**City of Bellevue
Development Services Department
Land Use Staff Report**

Proposal Name: Fotoohi Deck Addition

File Number: 22-113538-LO

Subject: **RESPONSE TO BELLEVUE CORRECTIONS COMMENTS**
Proposed New Deck Addition
5832 – 155th Avenue Southeast
Bellevue, Washington 98006

SITE PLAN

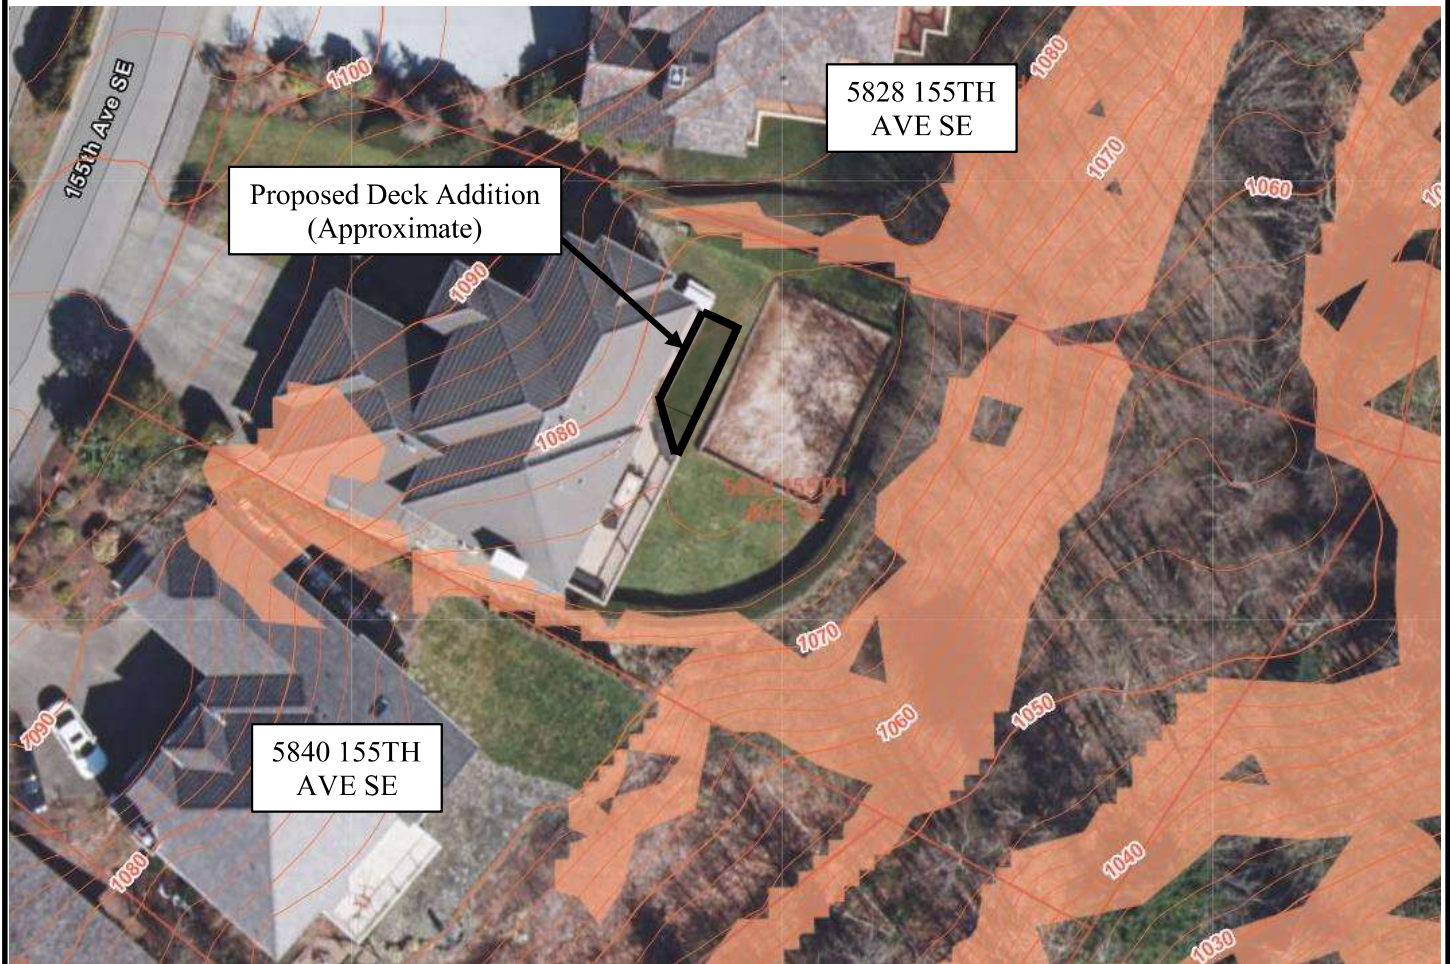
Correction Item #1:

Please show the following on the site plan:

- steep slope top-of-slope buffer (50’)
- proposed reduced buffer (15’)

- mitigation: potential mitigation includes installing trees, planting plan, removal of invasive species (i.e. blackberry or ivy), etc.

Correction Item #2:

Based on the GeoTech Report there is existing grass where the proposed buffer reduction is located. Please note how the proposed deck project will improve habitat functions. Adding a 200sf mitigation area (2 native trees or 200sf planting area) will improve functions, as the current area is degraded (just lawn and retaining wall). Trees: 2-inch caliper, 6' tall, staked. Trees and plantings should be located within the steep slope or buffer.

Need to note on the plan that the trees/planting area will be maintained and monitored to ensure health and survival.

The above referenced Site Plan B has been updated to include the requested information. Updates to the Site Plan are noted in red ink, and include a circled number to identify the revision submittal they were for (i.e. circled 1 for the first revision submittal).

Based on our discussions with the property owner, the proposed deck project will result in a net increase in habitat functions [LUC 20.20.230] by including installation of two (2) native trees. Acceptable species of trees include: big-leaf maple, red alder, and western red cedar, per Bellevue's Critical Areas Handbook. The trees are to be installed within the steep slope area, and are illustrated on the revised version of the referenced Site Plan B. Included in the revised

version of the site plan is the requested note expressing that the trees will be maintained and monitored to ensure health and survival.
